**1<sup>st</sup> ADDENDUM to the COMMENTS  
on the  
ENVIRONMENTAL IMPACT ASSESSMENT  
IMPLEMENTATION OF NEW NUCLEAR POWER PLANT UNITS AT THE PAKS SITE  
made by MVM Paks II Zrt**

Ir. Jan Haverkamp  
expert consultant on nuclear energy and energy policy  
for Greenpeace in Central and Eastern Europe  
20 October 2015

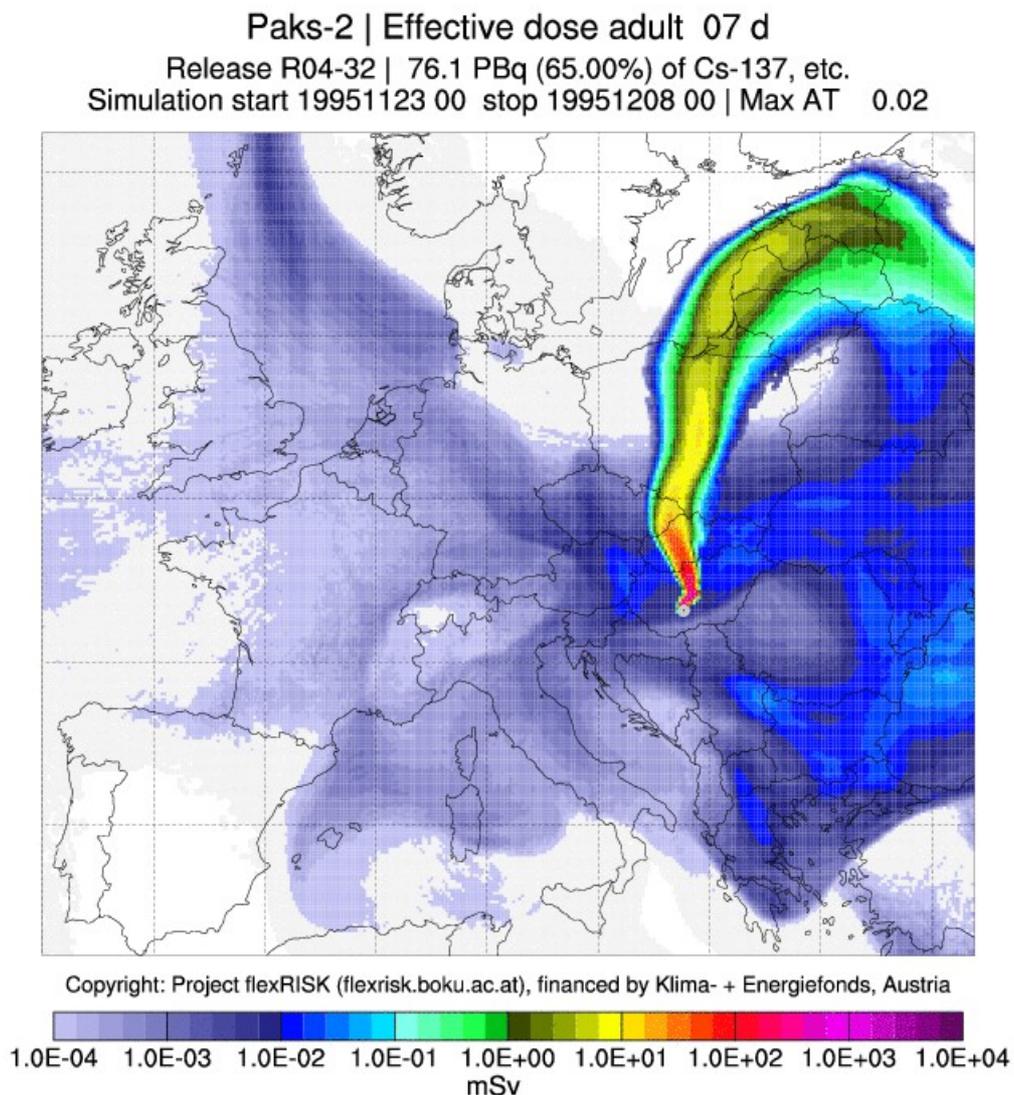
147. Page 28 – It is unclear what the maps and the dose-rates are indicating. Is this on the basis of one day of particular weather circumstances? If so, what weather circumstances are these

(dates)? Or is it a stochastic risk level? If so, how is that calculated? And what are the respective dose-limits under the ICRP limits of 1 mSv/yr and 20 mSv/yr or any more stringent limits in Hungarian law?
